CHAMBERS, TROY

Office Action Summary

10/033,161

FIG. 2

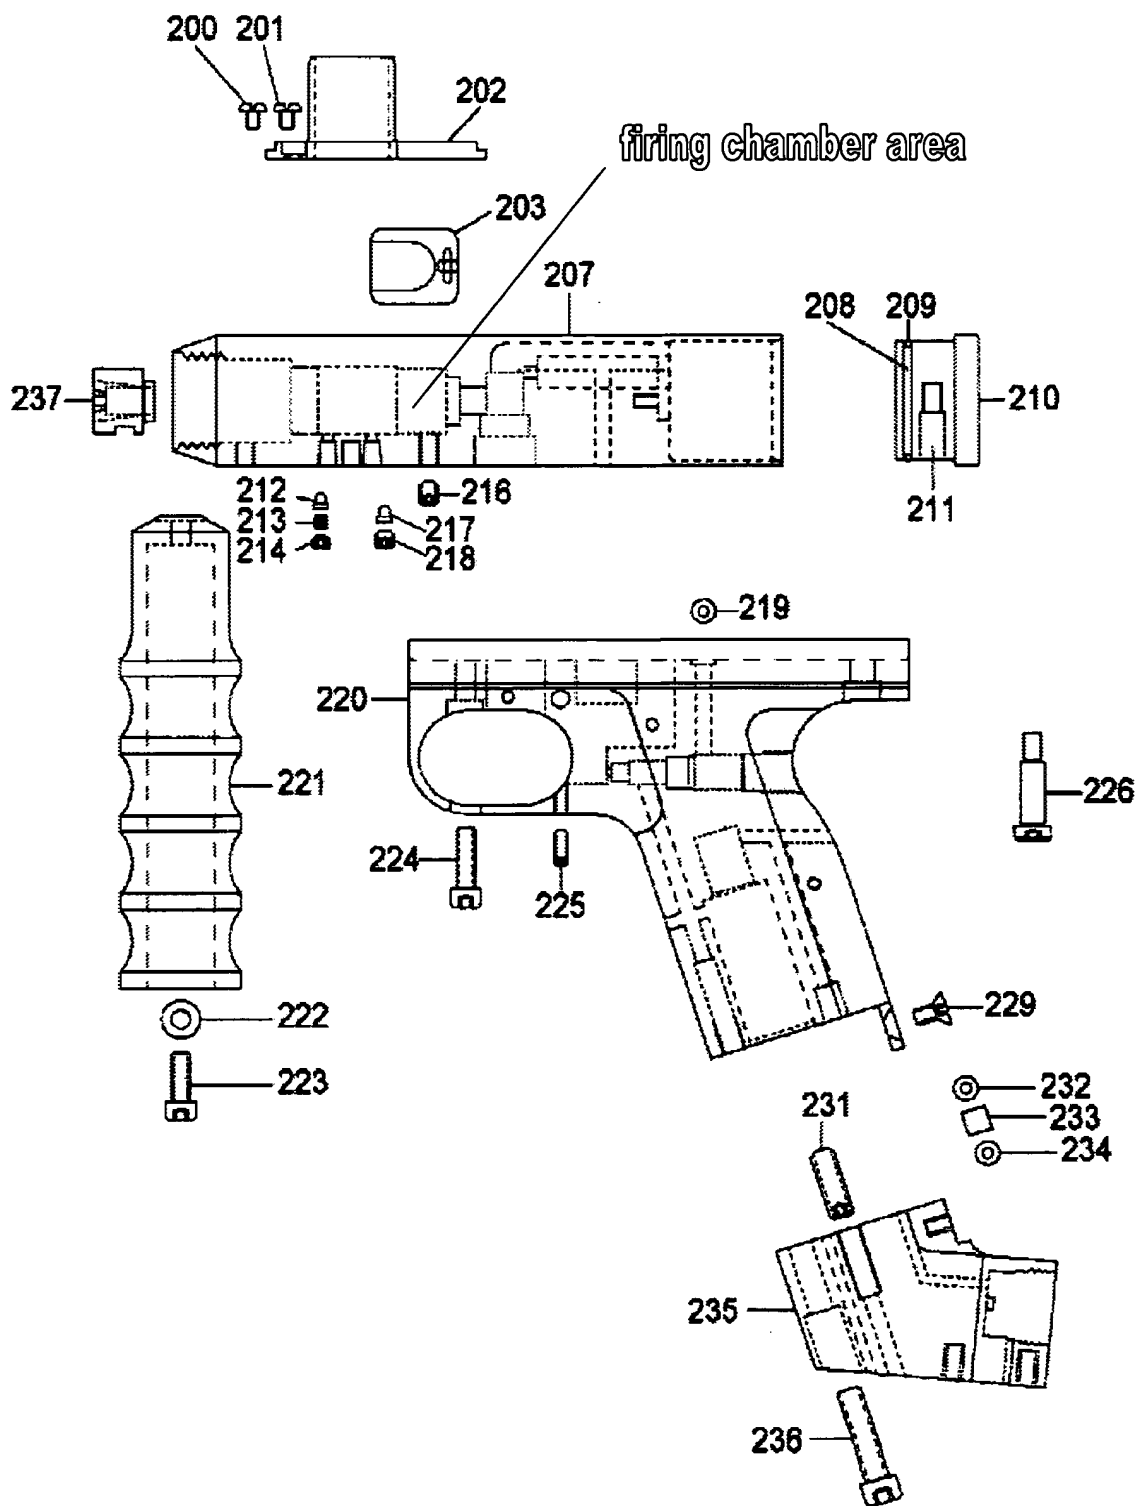
The true firing chamber taught by Reible, and shown directly to the left of the diffuser 237 in Fig. 14, does not include all of the associated elements identified by the examiner in the above-identified Office action as required by the claims. Particularly, the true firing chamber of Reible does have a barrel 102 directly to the left of the firing chamber (see Fig. 1). However, the rear cap 210 taught by Reible (referred to by the examiner as the 'removable back plug 208') is not located at an end of the true firing chamber taught by Reible and shown in Fig. 14."

The Examiner agrees with the applicant insofar as there is an admission that the firing chamber disclosed by Reible is shown as being located to the left of the diffuser. As shown below in Fig. 2, the diffuser 237 is to be located in an unnumbered passage

FIG 13

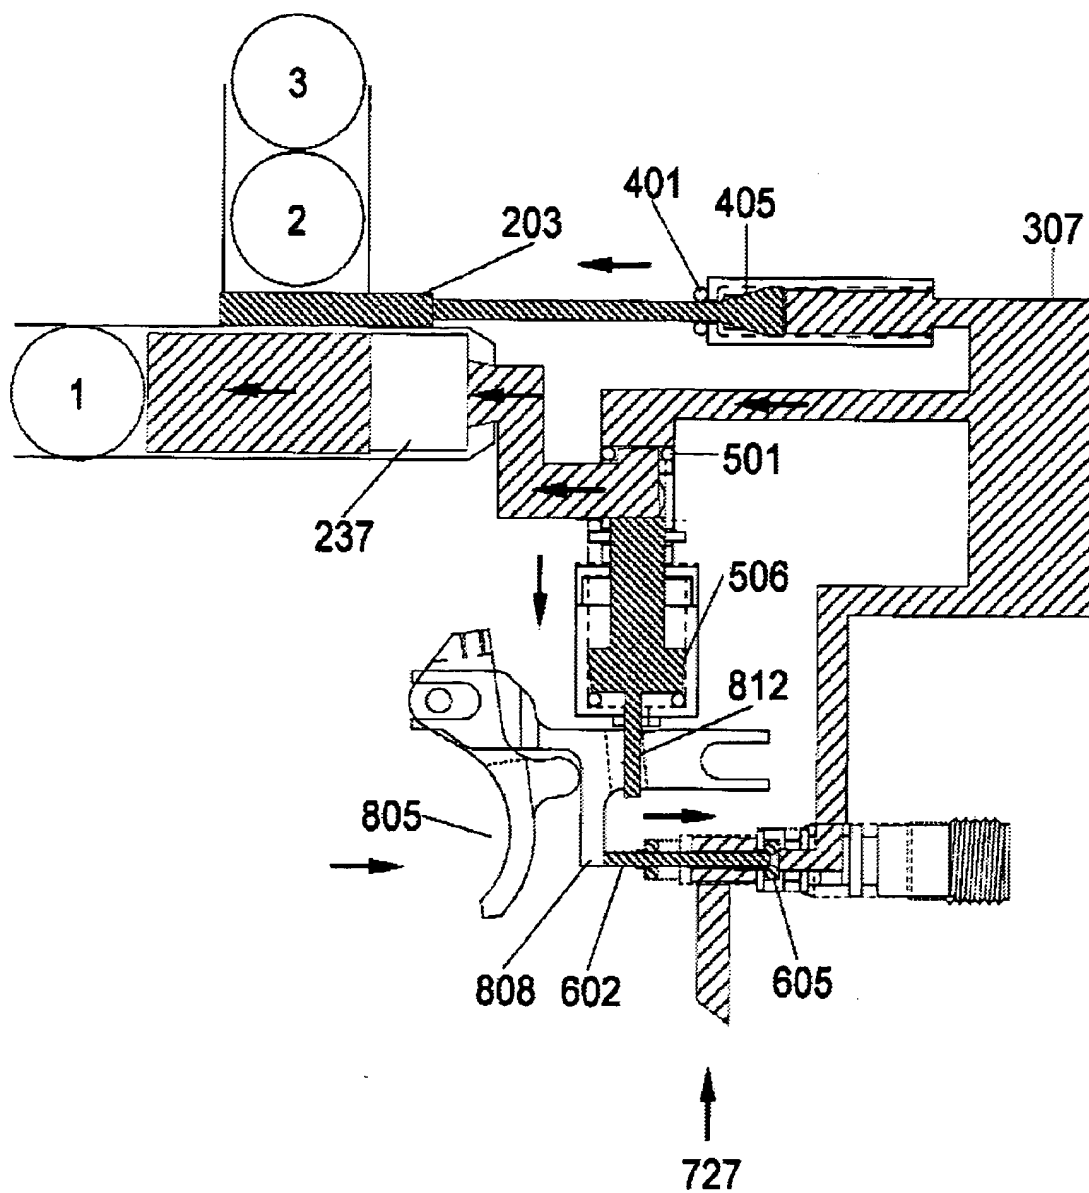
within body 207. The unnumbered passage (labeled 'firing chamber area' by the Examiner) extends to the left to include a threaded area for attaching a barrel as agreed by the applicant. However, Fig. 13 shows us that the firing chamber is further defined by the storage cavity 307 as well as the passage leading from the storage cavity 307 to the area defined by the location of the diffuser and paintball. Referring to Fig. 12, when the storage cavity 307 is fully charged a piston 506 operates to seal the passageway between the storage cavity 307 and the area occupied by the diffuser. But, in Fig. 13, the piston 506 is retracted and the entire area defined by the cross-hatchings becomes the firing chamber.
